**MMEL IG Meeting 78 Agenda
April 28-29, 2010
Chicago, IL**

AGENDA ITEM DETAILS

757 Annunciator Panel

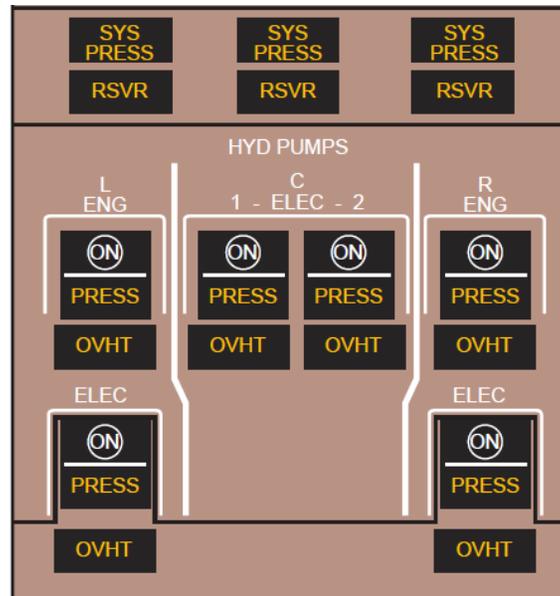
MMEL Relief Available for Some of the Associated Systems & Annunciator Lights, but not for Single Bulb Failures

Typical Audio Panels

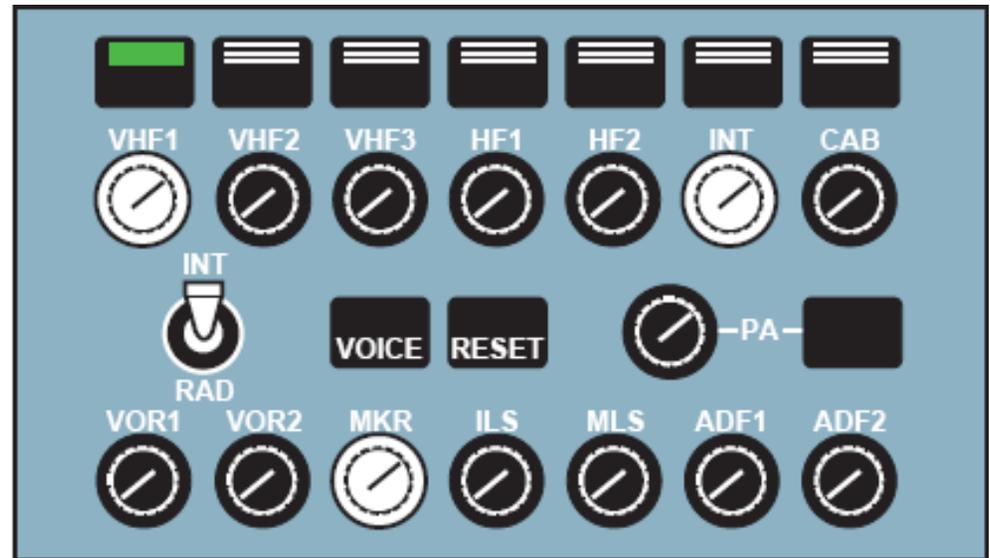
MMEL Relief Available for Individual Functions and Panel Overlay, but not for Pushbutton Selector Lights

757/767 FMS MCDU EXEC Light

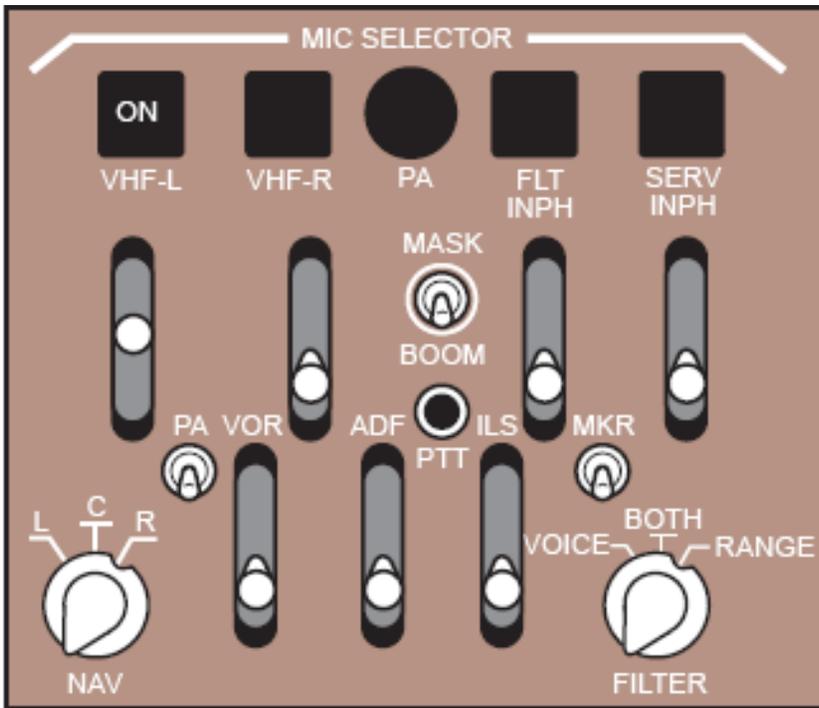
MMEL Relief Not Available for EXEC Light
